Port Colborne Quarries – Proposed Pit 3 Extension

ROPA, LOPA, ZBLA Applications – List of Technical Material Submitted

JART Comment Letters

Figure 3 - Port Colborne Minimum Temperatures (1965-2006)

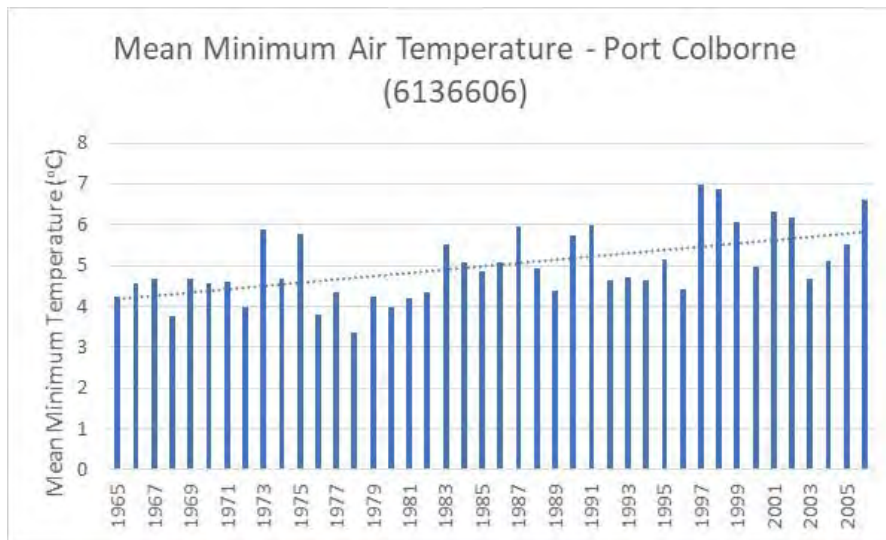
11. Table D-1 presents the monthly water budget over the 1965-2018 time frame. Is the 1965-2018 time frame reflective of the climate conditions currently experienced in the study site? As the climate has warmed since the mid-60's (see Figure 3), using this time period may not be reflective of current evapotranspiration rates. Are the water budget calculations sensitive to using a more recent 20 year period?

11. Table D-1 presents the monthly water budget over the 1965-2018 time frame. Is the 1965-2018 time frame reflective of the climate conditions currently experienced in the study site? As the climate has warmed since the mid-60's (see Figure 3), using this time period may not be reflective of current evapotranspiration rates. Are the water budget calculations sensitive to using a more recent 20 year period?

Appendix 2: Agricultural Impact Assessment Comments

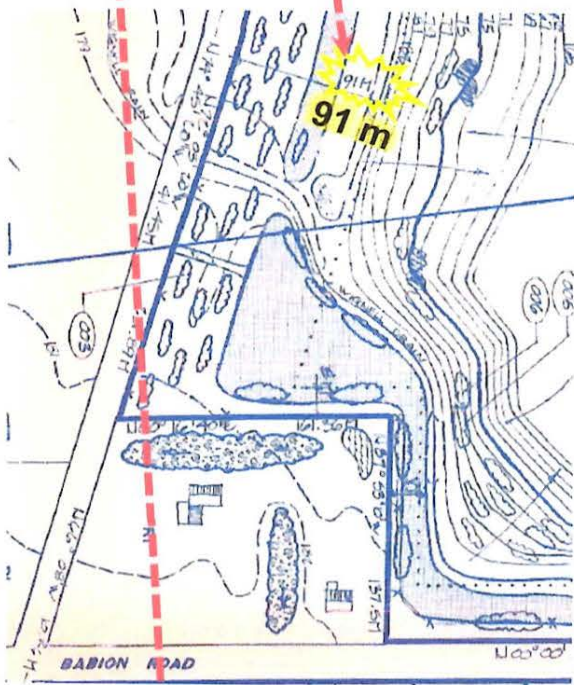
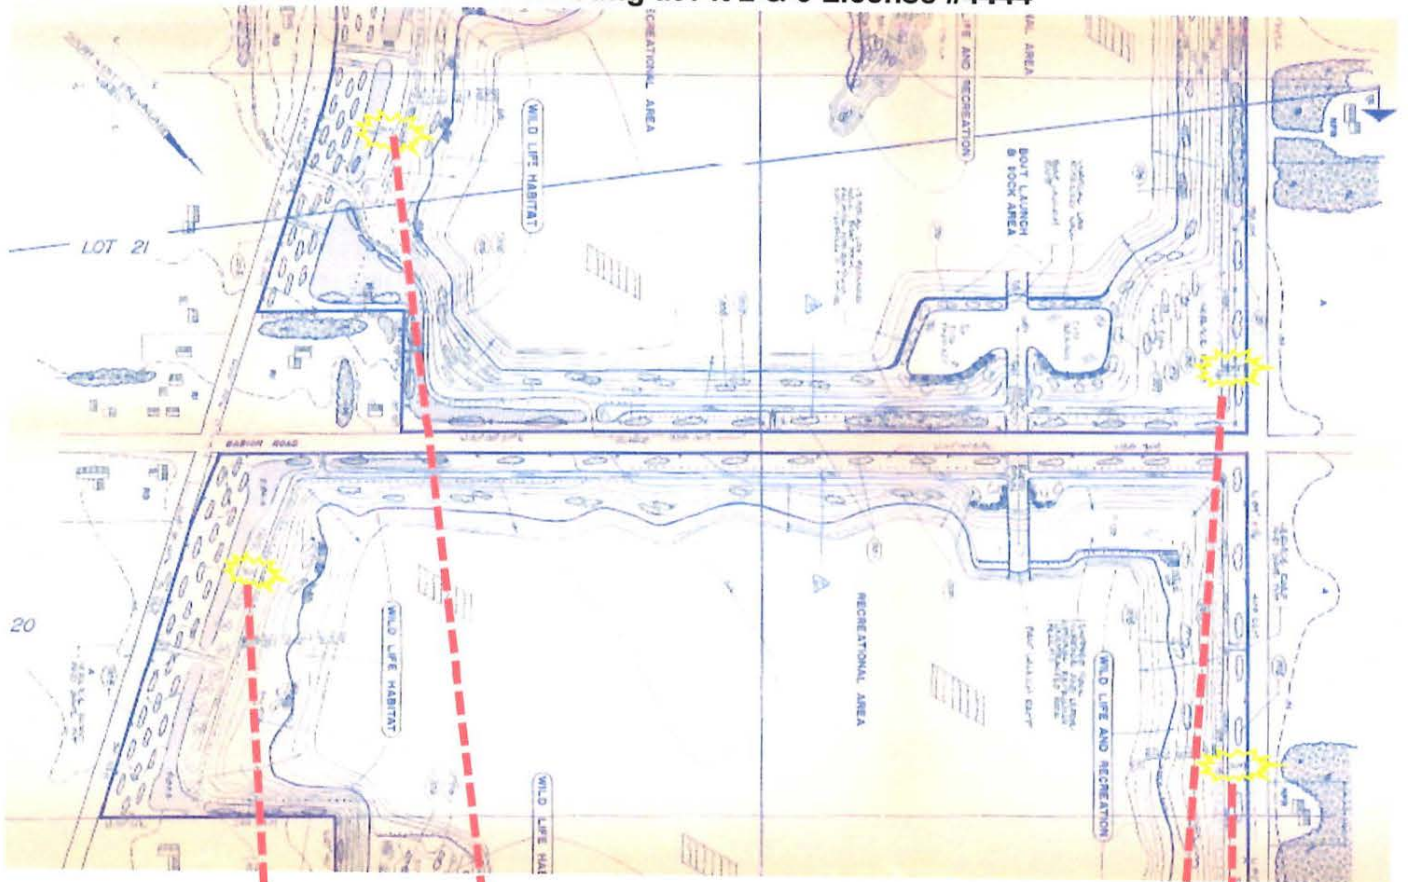
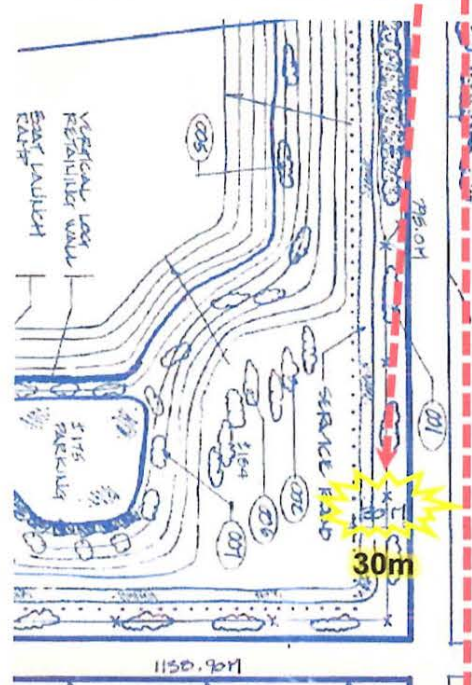
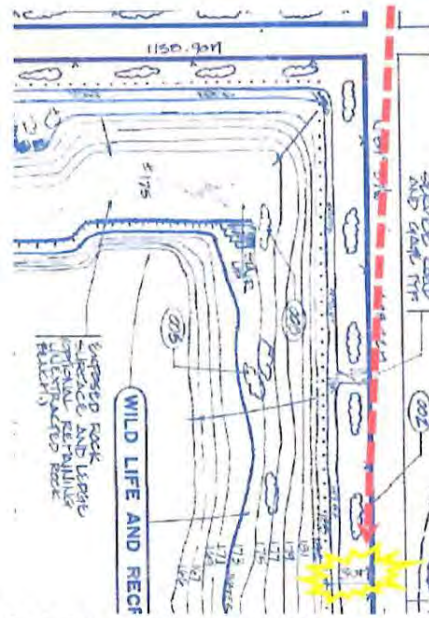
22. S. 6.8, Page 64 – As noted above, a Special Policy in the OPA will be required to permit the existing detached dwellings.
23. S. 7.1, Page 66 – Will the Environmental Site Assessment (ESA)/soil management plan recommend the Humberstone Speedway soils be used on

site, rather than being disposed of? This is of specific concern to neighbouring property owners, and will be a key issue with the application. The PJR should be updated to reflect the recommendations of the Phase 1 ESA and soil management plan, with an outline of next steps and a timeline for future work required.
